# ENGINEERING AND CONSTRUCTION BULLETIN

No. 2008- 11 Issuing Office: CECW-CE Issued: 27 Mar 2008

**Subject:** Marking of Army Airfield-Heliport Operational and Maintenance Facilities

75 Foot Wide Runway Revised Non-Precision and Precision Runway Standard Threshold Runway Markings Revised 2008

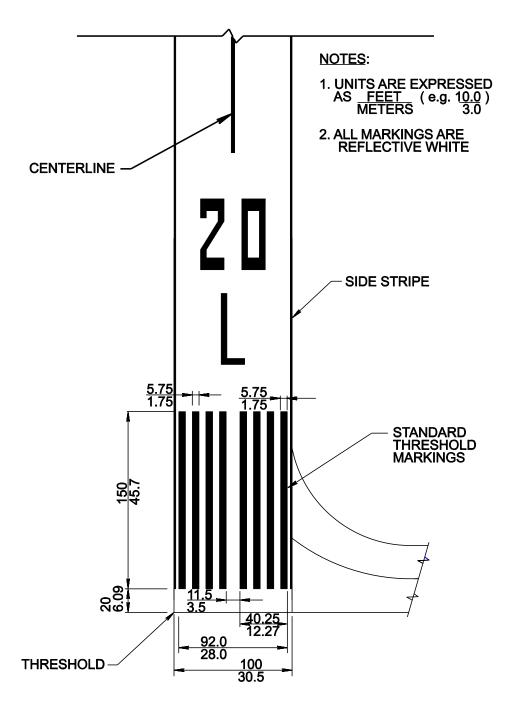
- 2. This ECB provides current criteria for marking U.S. Army airfield pavements, including additional criteria and changes to UFC 3-260-05A. Chapter 2 of UFC 3-260-05A shall be used for marking all U.S. Army runways with the following exceptions: Threshold markings shall be in accordance with the attached revised threshold markings for precision and non-precision runways. Heliports shall be marked in accordance with Chapter 3 and 4 of UFC 3-260-05A. All other markings shall be in accordance with AF ETL 04-02 and AFI 32-1042.
